PCN – Product Change Notification

PCN-A-111018

PCN Topic: 24" S1 panel (1920x1200) will be replaced by 24" A1 panel (1920x1080).

Open Frame mechanical dimension is changed

The below pictures show the example of how the new mechanic differ from Original one.

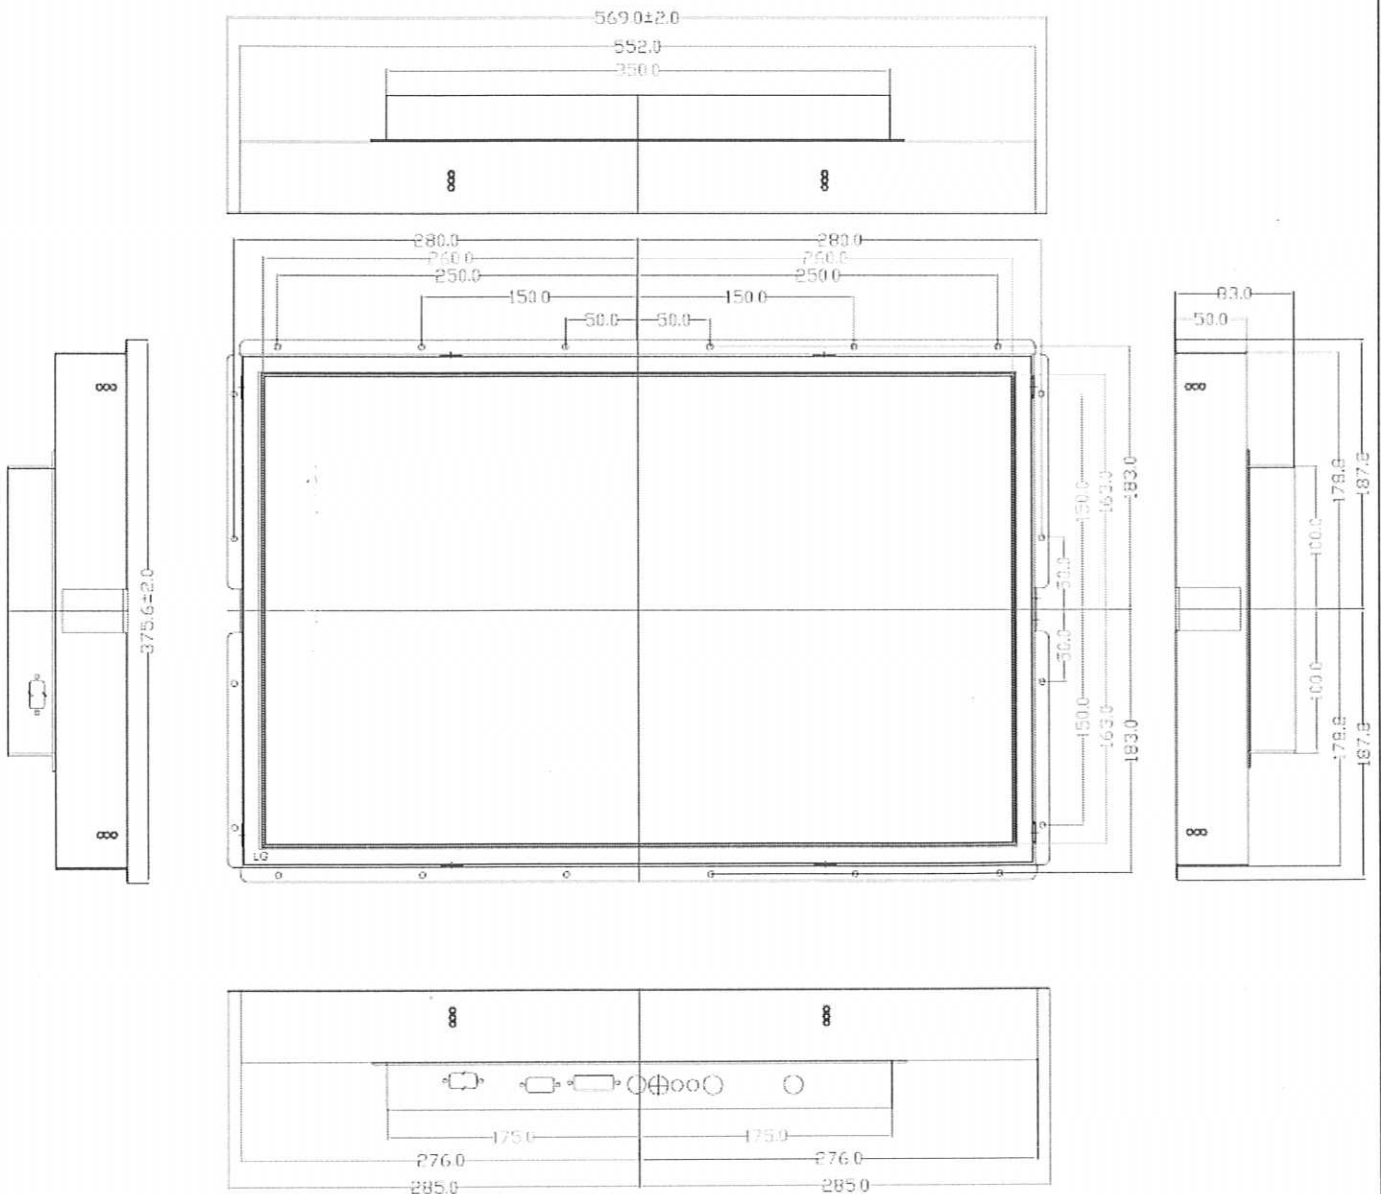
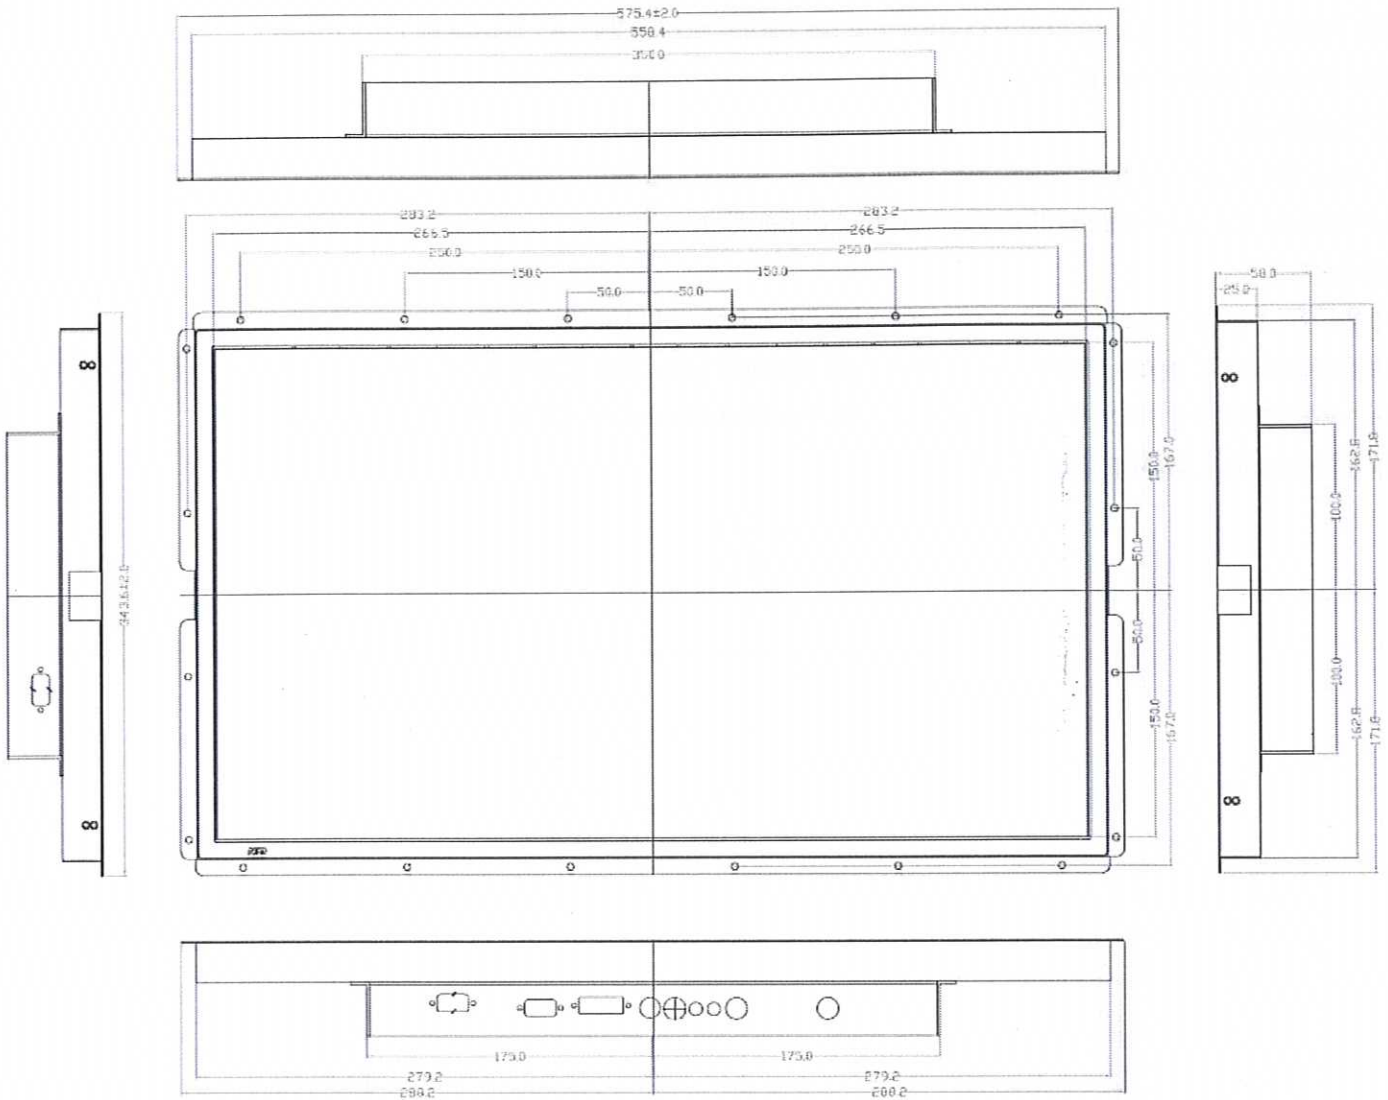
The 24" S1 panel (1920x1200) is replaced by 24" A1 panel (1920x1080):

The dimension of **open frame** mechanical will change from 569 X 375.6X 83 mm to 575.4 X 343.6 X 58 mm.
